Revisions to the Agenda City Council

6.e. [17-616](#)

CLASS 3 SITE PLAN REVIEW / CLASS 2 ADJUSTMENT / CLASS 2 DRIVEWAY APPROACH PERMIT CASE NO. SPR-ADJ-DAP17-26

SUMMARY: Proposed redevelopment of existing property, including removing existing buildings and development of three new retail/office buildings and parking area.

1 OVERALL SITE PLAN
SCALE: 1" = 30'-0"

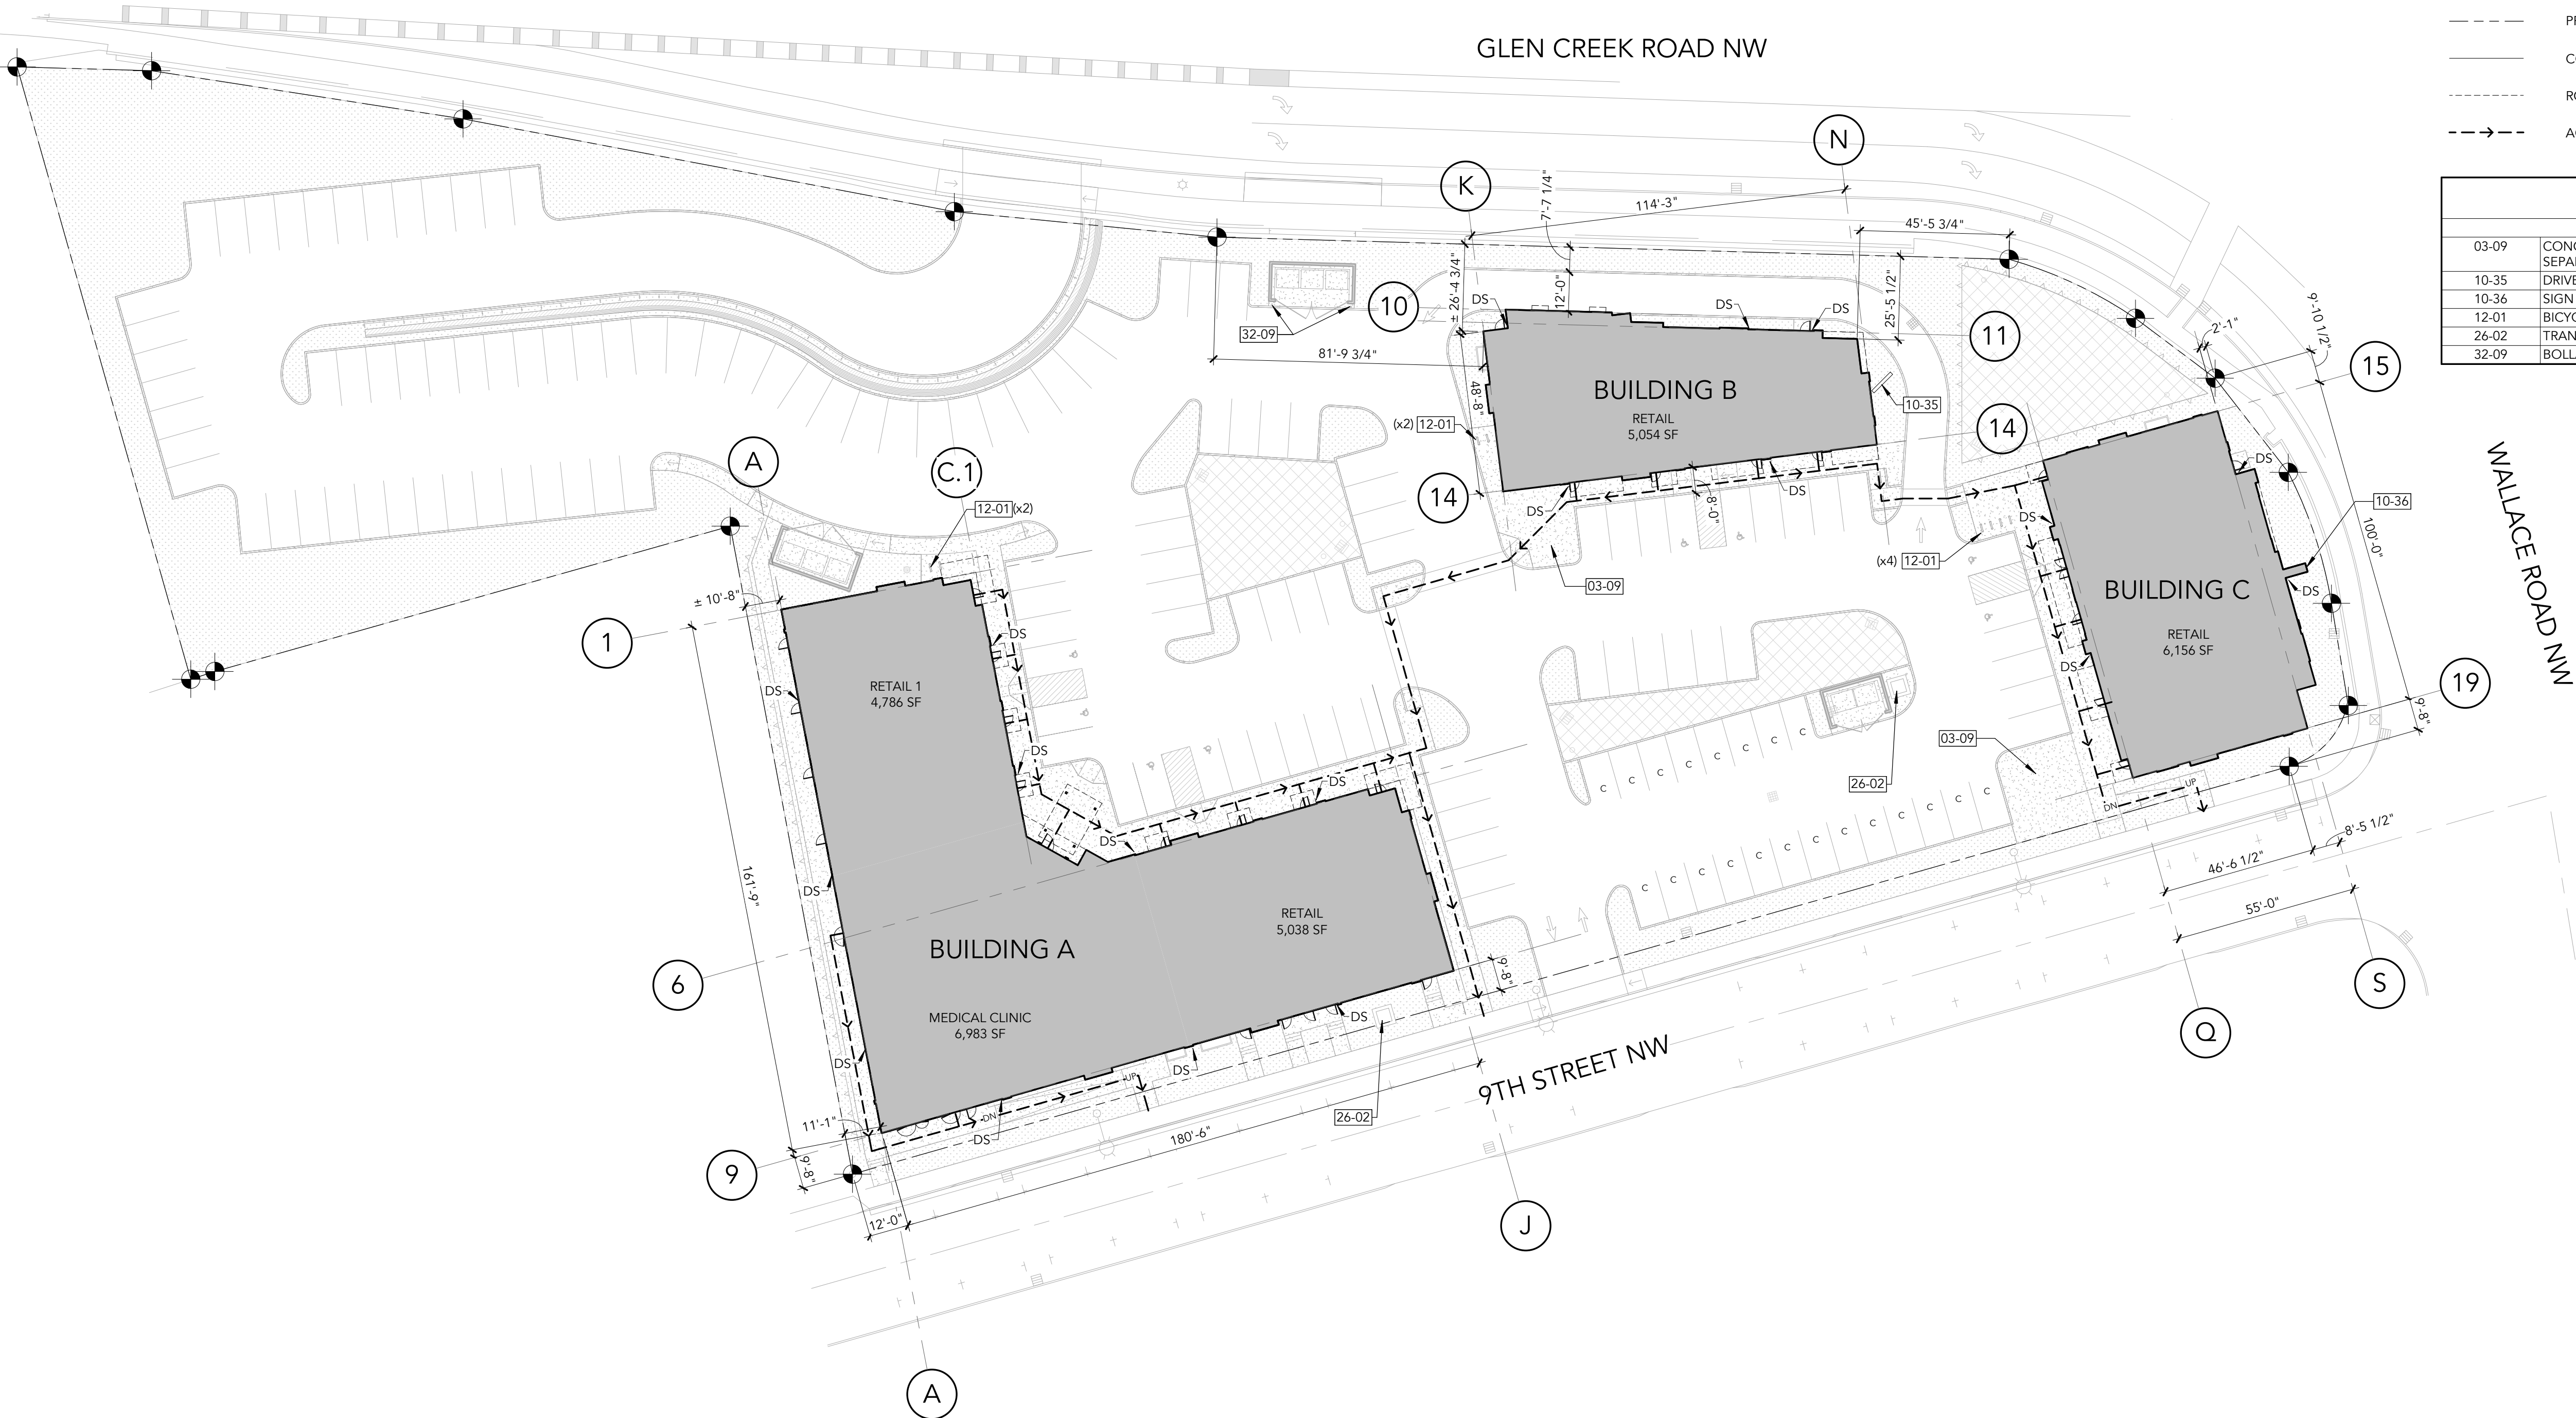
Finding: The proposed site plan indicates that bicycle parking spaces will be provided near the entrance for proposed buildings A and C, however the proposed bicycle parking location for Building B is not visible from a primary building entrance and will need to be relocated.

Condition 1: Bicycle parking spaces for Building B shall be relocated so it is clearly visible from the primary building entrance. In no event shall the bicycle parking spaces be located more than 50 feet from the primary building entrance.

DEACON DEVELOPMENT
THE POINTE AT GLEN CREEK
UTILITY PLAN

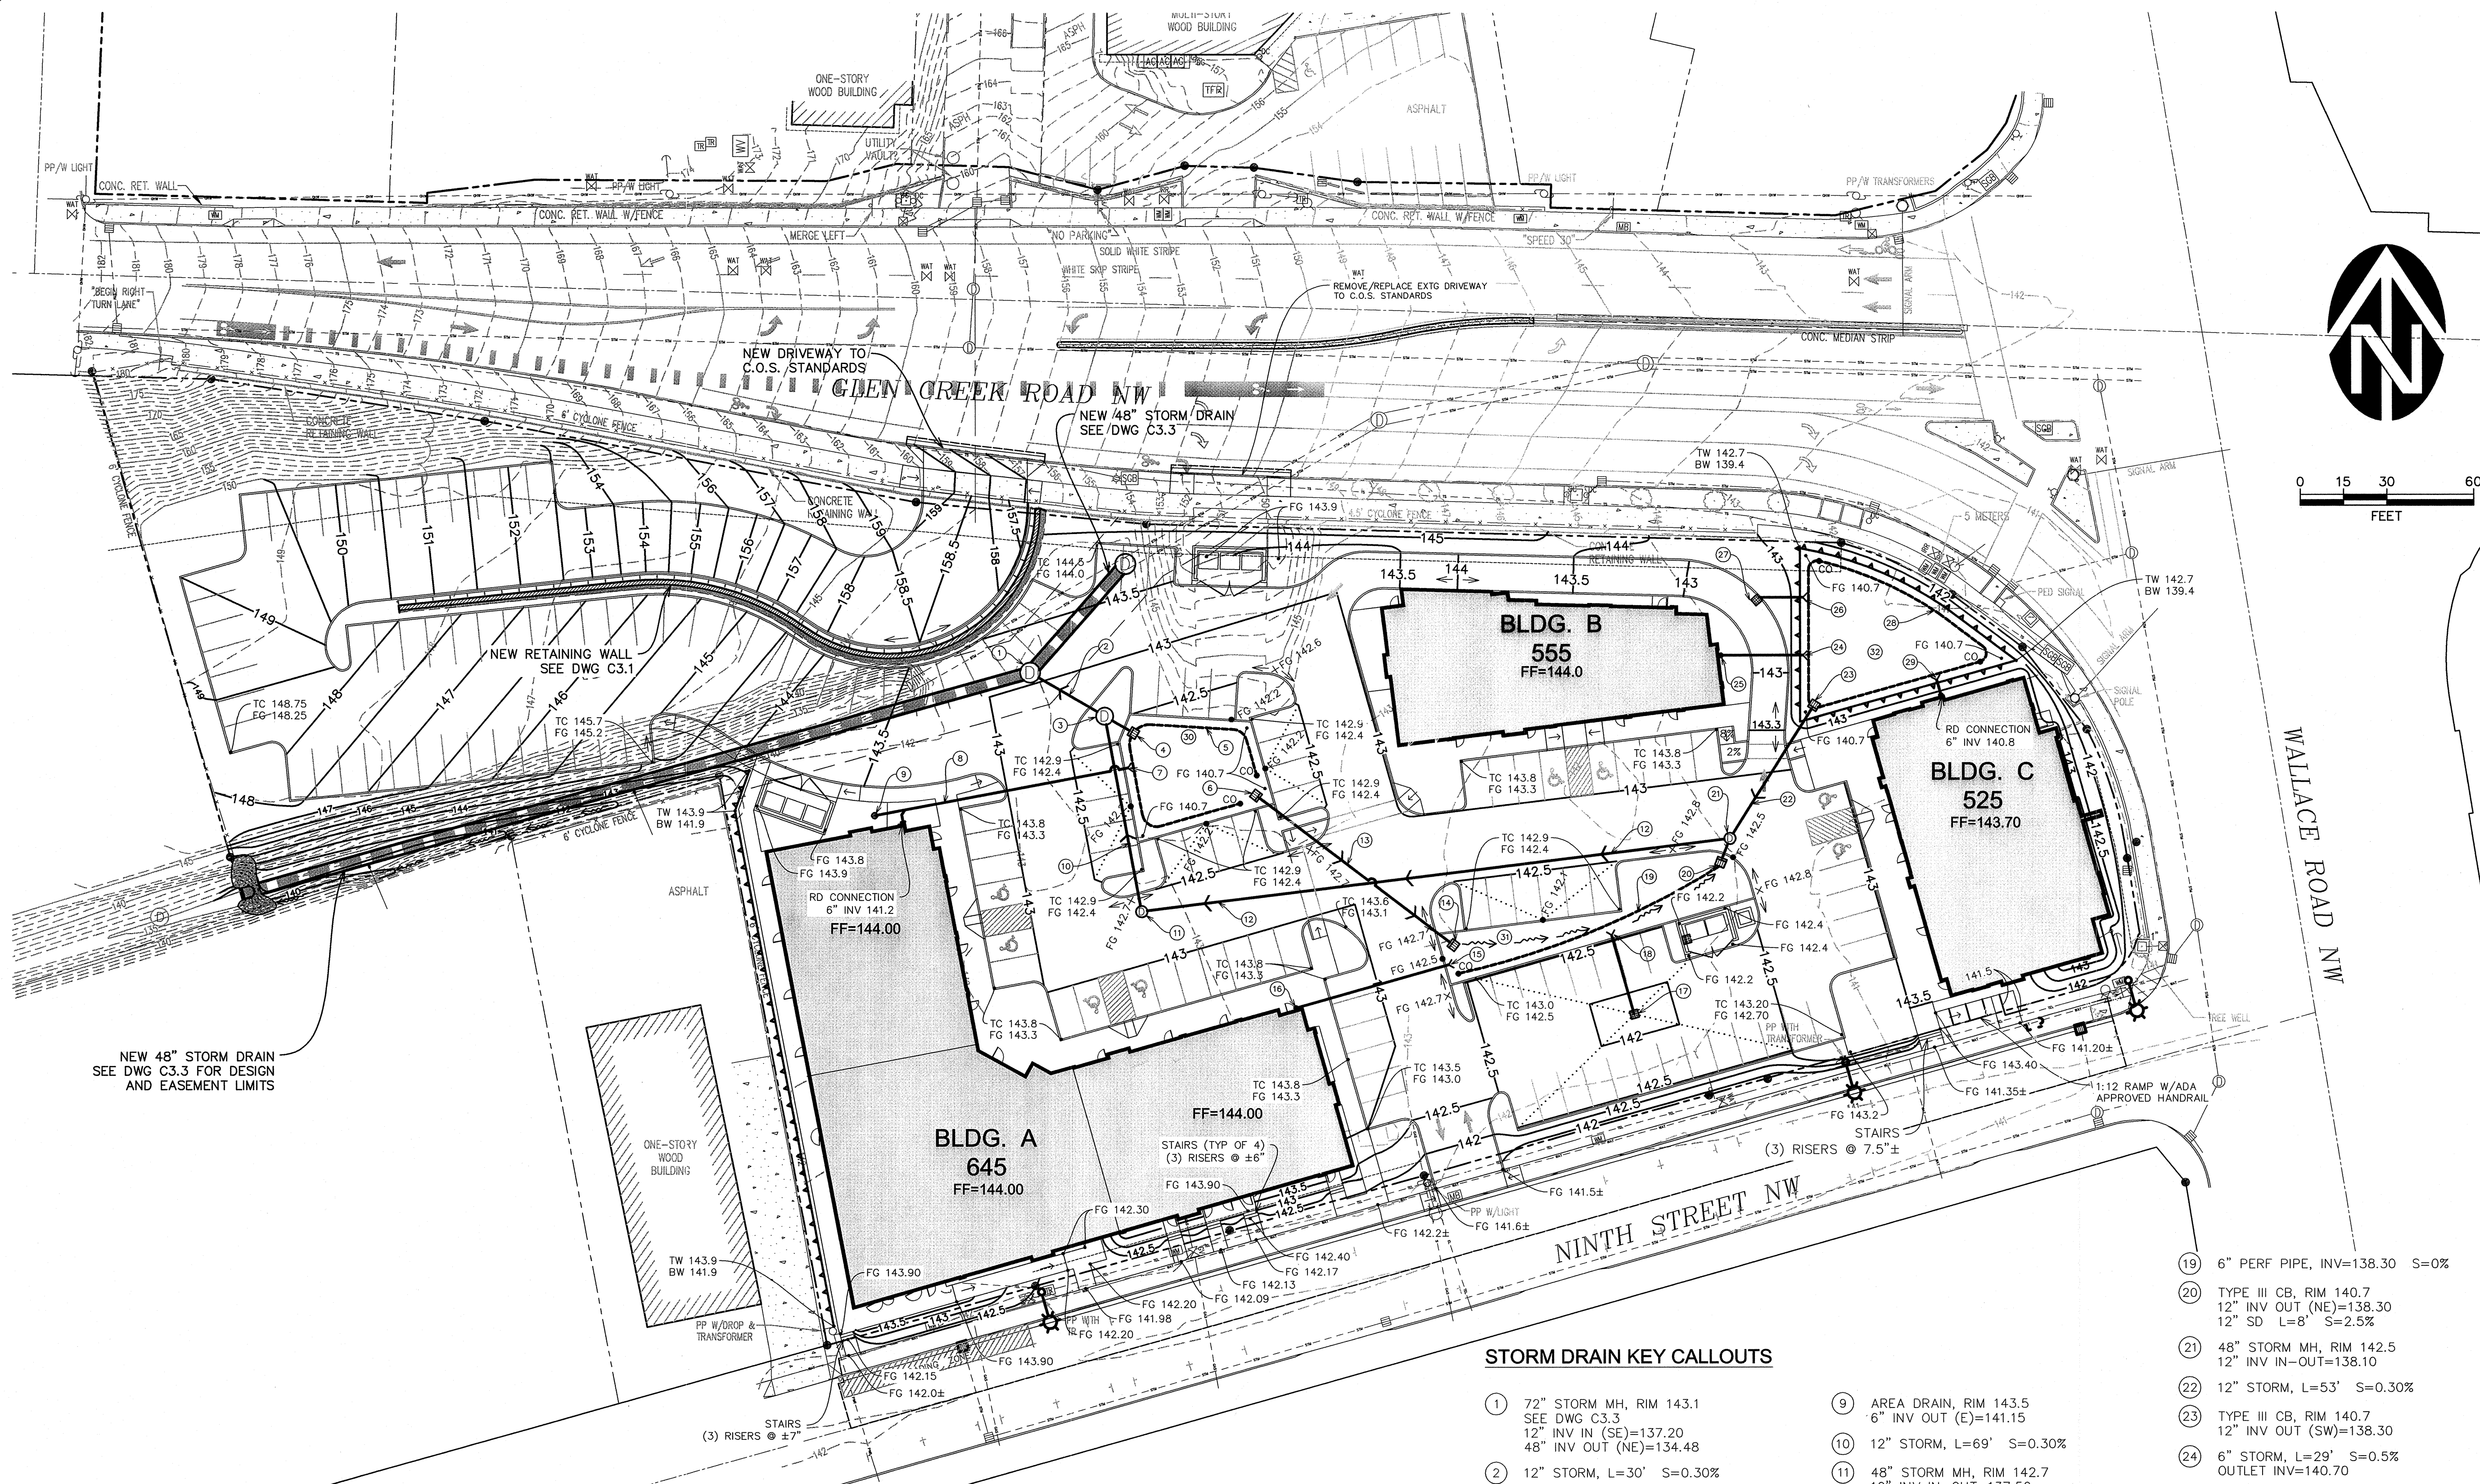
Finding: The Public Works Department has reviewed the applicant's preliminary utility plan for this site. The water, sewer, and storm infrastructure are available within surrounding streets / areas and appear to be adequate to serve the proposed development. The applicant shall design and construct all utilities (sewer, water, and storm drainage) according to the PWDS and to the satisfaction of the Public Works Director. As specified in the conditions of approval, the applicant shall dedicate a 25-foot public storm easement along the full length of the proposed 48-inch storm main extension at the northwest corner of the subject property. Acquisition of an easement from the neighboring property owner may be required to meet the minimum easement width of 25 feet unless modified under a design exception by the City Engineer.

- Condition 4:** Dedicate a 25-foot public storm easement along the full length of the proposed 48-inch storm main extension pursuant to PWDS. Acquisition of an easement from the neighboring property owner may be required to meet the minimum easement width of 25 feet unless modified under a design exception by the City engineer.
